SPECIFICATION
FOR
HIGH VOLTAGE CABLE WITH PLUG
FOR
WAG-9/WAP-7/WAP-5 ELECTRIC LOCOMOTIVES

Specification No : CLW/ES/3/0251 (Rev~~1~~2 ~~December-06~~)

DY.CHIEF ELECTRICAL ENGINEER/D-I
CHITTARANJAN LOCOMOTIVE WORKS
CHITTARANJAN – 713331
Dist: BARDHAMAN (WEST)
WEST BENGAL (INDIA)

ALTERATION RECORD SHEET

आरेखण संख्या DRAWING NO.: CLW/ES/3/SK-1/0251 REV. 2 ~~(DEC.06)~~

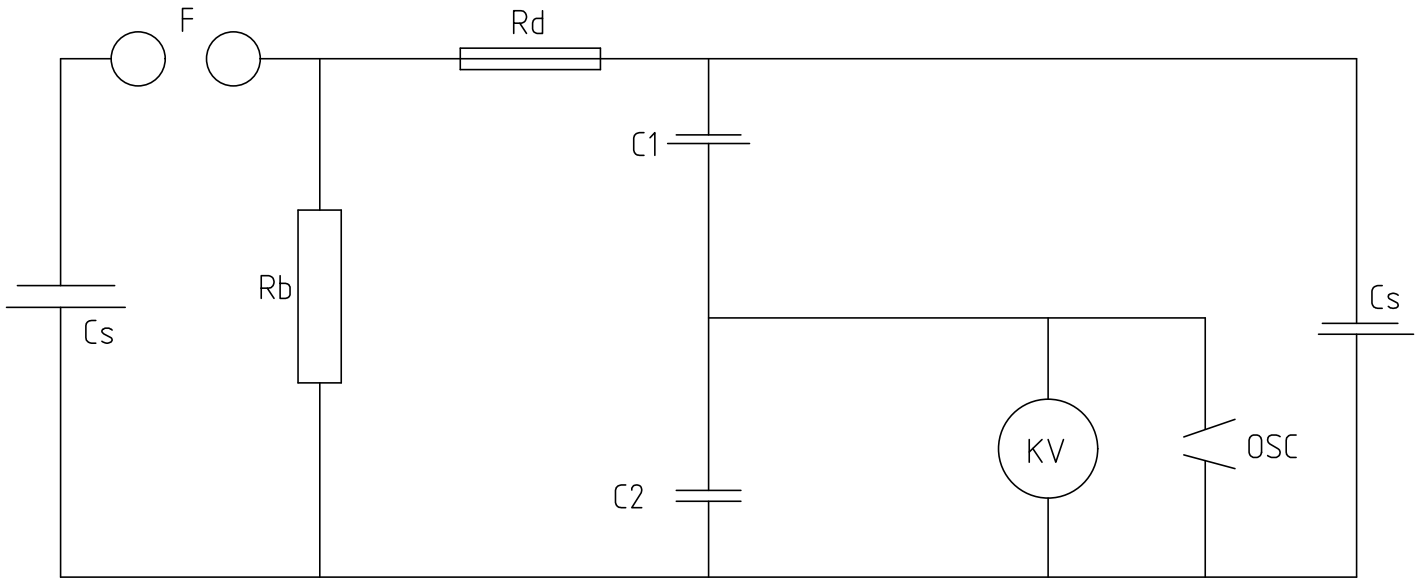
xiii) Cl.no.7.1 to cl.no.7.6 is included. xiv) Cl.no.8 Test condition has been deleted. xv) Test connection under Cl.no.8 is deleted and included in drg.no.CLW/ES/3/SK-1/0251 Rev-~~1~~ 2, ~~Dec 06.~~ xvi) In Sub Cl.no. 9.3, Material composition of Elbow Connector, Stud, Thread of FAL-PLUGS 755 LR and copper lugs is mentioned. xvii) Cl.no.10 Reference type and Cl.no.11 General Condition have been deleted. xviii) Cl.no.12.0 Lebel and Marking have been modified. xix) NOTE is included in drawing no. CLW/ES/3/ SK-2/0251 Rev-2. xx) BOM at SN-4,5 & 12 have been modified in drawing no. CLW/ES/3/ SK-2/0251 Rev-2. xxi) Drawing of STUD (Ref:3EHW470010) is included in drawing no. CLW/ES/3/SK-3/0251 Rev-2.

Cs =Pulse capacitor
F = Switch on path
Rb = Load resistance
Rd = Damping resistance
CI, C2 = Voltage divider
KV = Voltmeter
OSC = Oscilloscope
Control of the ratio of the voltage divides is done by means of Voltmeter.
All equipment's used during testing shall be calibrated.
